September 15, 2010

Attn: Document Control Desk
Ron Linton
Project Manager
Uranium Recovery Licensing Branch
Division of Waste Management and
Environmental Protection
Office of Federal and State Materials and
Environmental Management Programs
U.S. Nuclear Regulatory Commission
Two White Flint North, MS T8F5
11545 Rockville Pike
Rockville, MD 20852

Re: Text Revisions to the Open Issues to the Safety Evaluation Report for the Nichols Ranch ISR
Project License Application (TAC J00553, Docket No 040-09067)

FIGURE D6B.6-5 DRAWDOWN IN OBSERVATION WELL URZNA-8

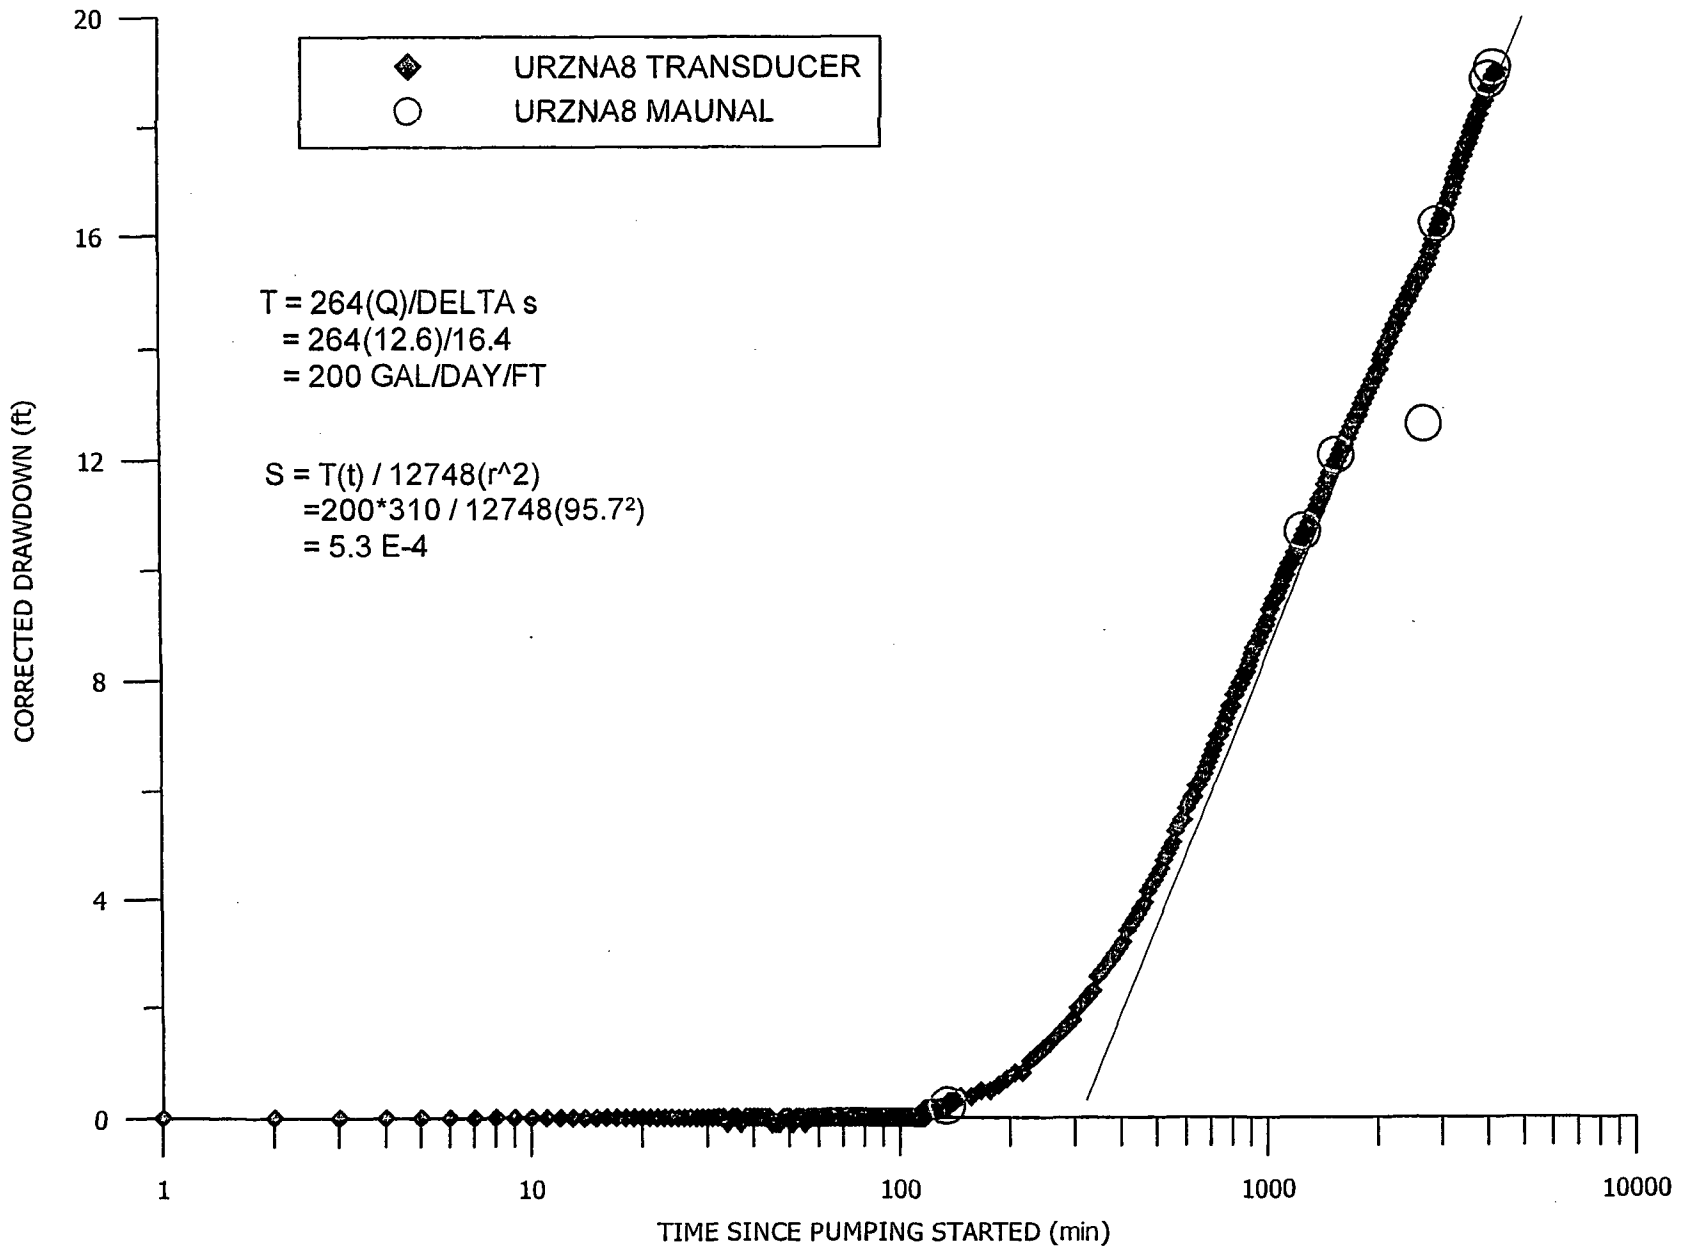
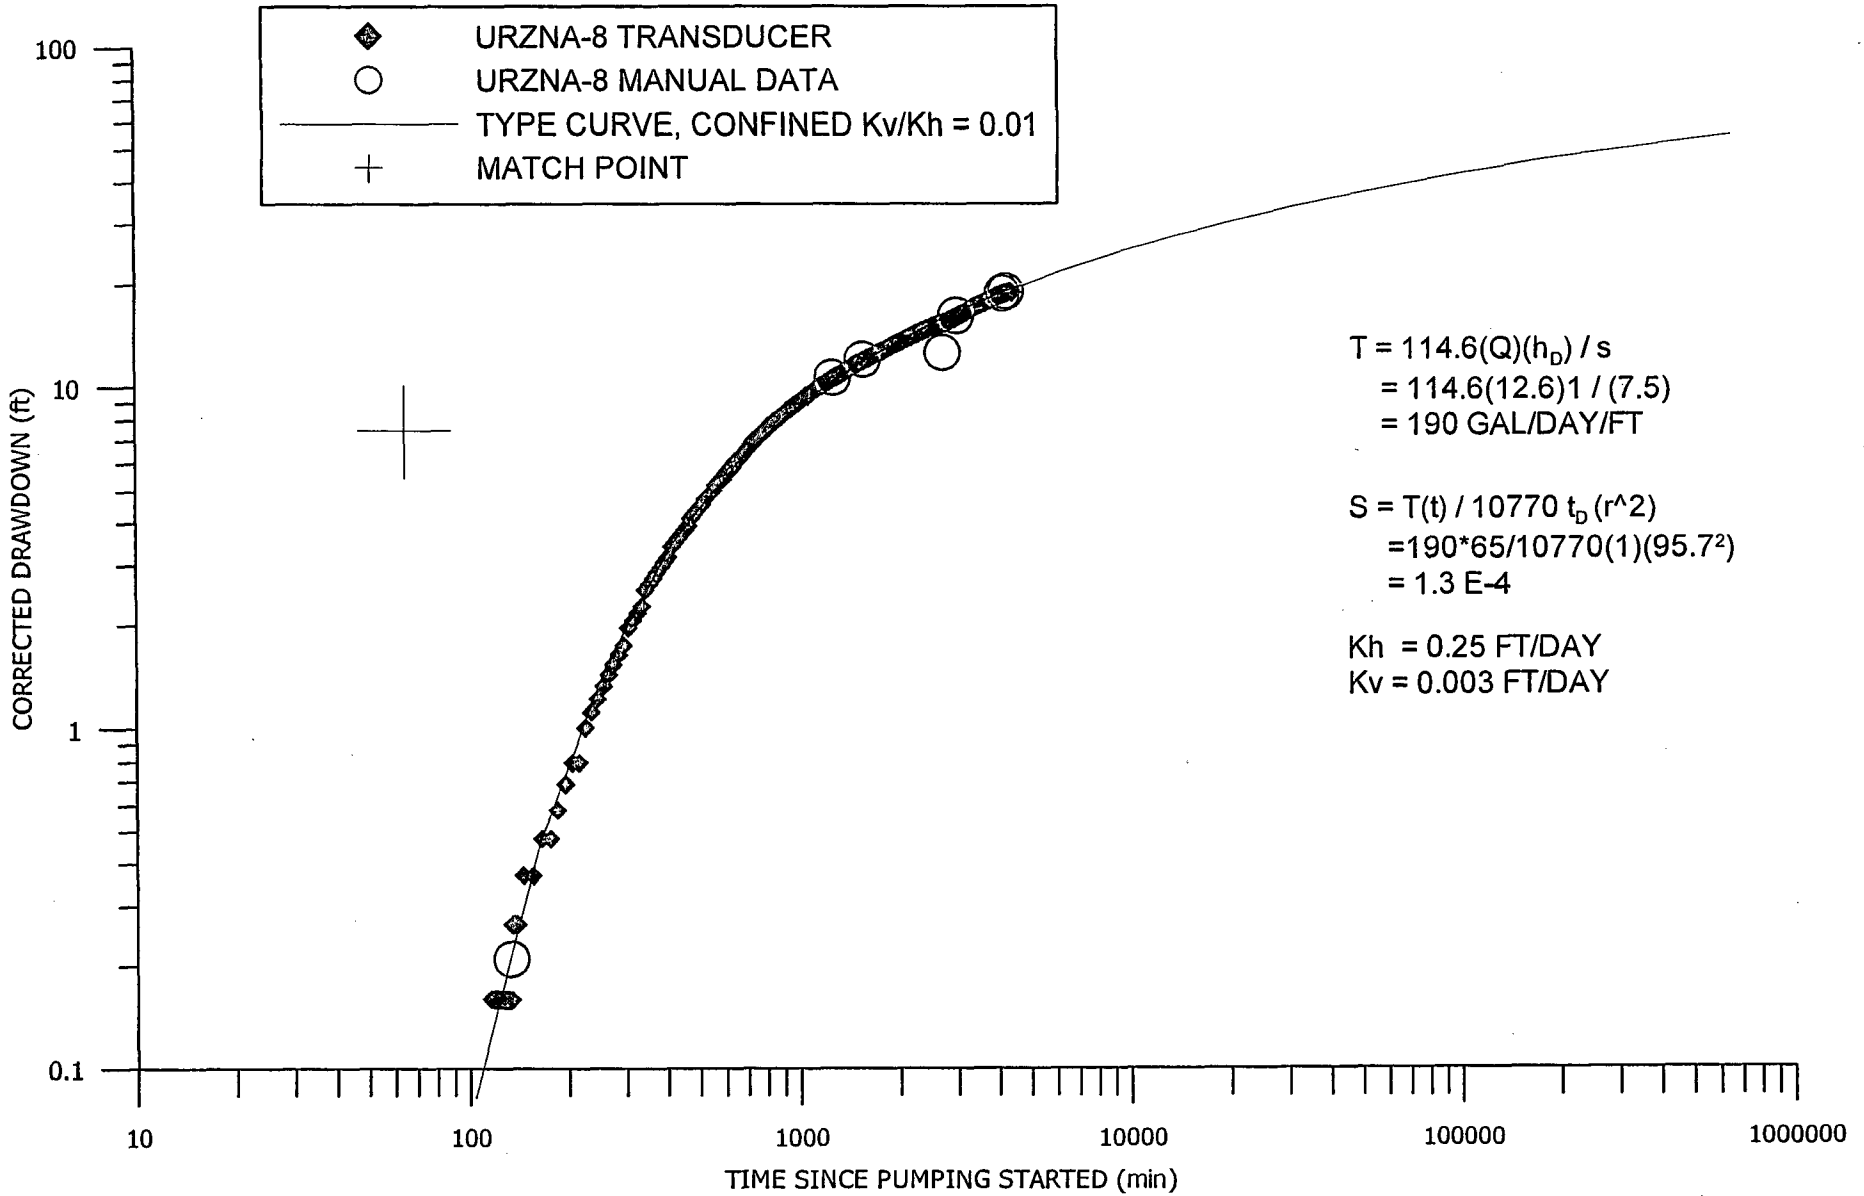
Volume VI, Appendix D6, Addendum D6B		Figures D6B.6-1 through D6B.6-13, April 2010, pgs D6B.6-4 through D6B.6-16	Figures added per Third Consolidated Review Comment 116-M.
Volume VI, Appendix D6, Addendum D6B		Tables D6B.6-1 through D6B.6-8, April 2010, pgs D6B.6-17 through D6B.6-42	Tables added per Third Consolidated Review Comment 116-M.
_____	_____	_____	_____
_____	_____	_____	_____
_____	_____	_____	_____
